Responses to Comments on the Draft IS-MND

This document includes comments received during the circulation of the Draft Initial Study-Mitigated Negative Declaration (IS-MND) prepared for the 22626 4th Street Residential Project (proposed project) and responses to those comments. The Draft IS-MND identifies the likely environmental consequences associated with development of the proposed project, and recommends mitigation measures to reduce potentially significant impacts. This Response to Comments (RTC) Document provides a response to comments on the Draft IS-MND and makes revisions to the Draft IS-MND, as necessary, in response to those comments or to make clarifications to material in the Draft IS-MND. This document, together with the Draft IS-MND, constitutes the Final IS-MND for the proposed project.

Subject: Friends of San Lorenzo Creek Comments on
The Draft Initial Study - Mitigated Negative Declaration for
The Housing Development at 4th and B Streets

Section 13.12.320: Setback Criteria (Excerpts only)

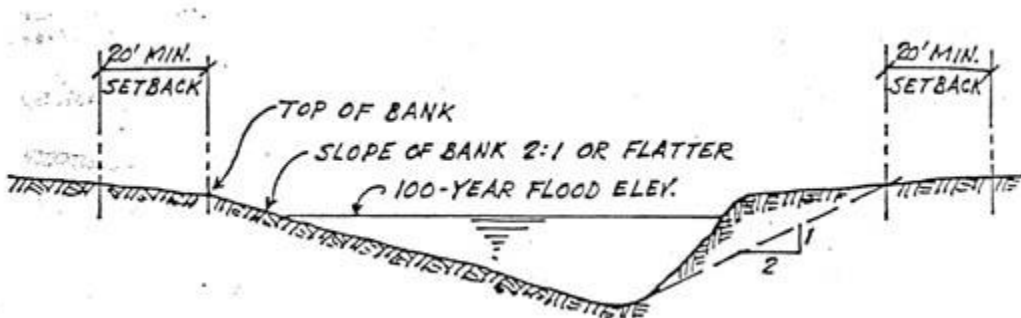
3 The City of Hayward applies the Alameda County Watercourse Protection Ordinance (WPO) to proposed development along creeks, including this proposed project. See Attachment A of these comments for excerpts from the WPO. The WPO establishes the setback area as a MINIMUM 2:1+20-foot setback with no "development," and states that "...the purpose of setbacks is to safeguard watercourses by preventing activities that would contribute significantly to flooding, erosion or sedimentation, would inhibit access for watercourse maintenance, or would destroy riparian areas or inhibit their restoration." In this case, fences, private back yards, and likely development that does not require permits (e.g., planting grass, paving, etc.) do damage the remaining riparian areas and inhibit their restoration. Fences, for example, block foraging and migration of many animals. Human activity, development, and private ownership inhibits riparian areas and their restoration by inhibiting natural habitat succession and/or future organized & human-directed replanting to achieve the native riparian area habitat.

4 The City of Hayward applies the Alameda County Watercourse Protection Ordinance (WPO) to proposed development along creeks, including this proposed project. The following should be included this regulatory setting section of the IS-MND: A discussion of the WPO, the stated purposes of the WPO (including protection of riparian areas and their ability to be restored), the WPO's 2:1 plus minimum 20-foot creek setback, WPO definitions of "development," and the proposed project's backyard encroachment into the WPO setback and riparian area.

The commenter's interpretation of the WPO and how it applies to the project is incorrect. The project site is in the jurisdiction of the City of Hayward and not unincorporated Alameda County. The County's WPO (Chapter 13.12 of the General Ordinance Code of the County of Alameda) only applies to land within the County's jurisdiction and therefore does not apply to the project. Although the City of Hayward uses the County's WPO as guidance, the requirements have not been codified in the Hayward Municipal Code.

Please see Response 1.3. As noted under Response 1.3, the County's WPO does not apply to the project.
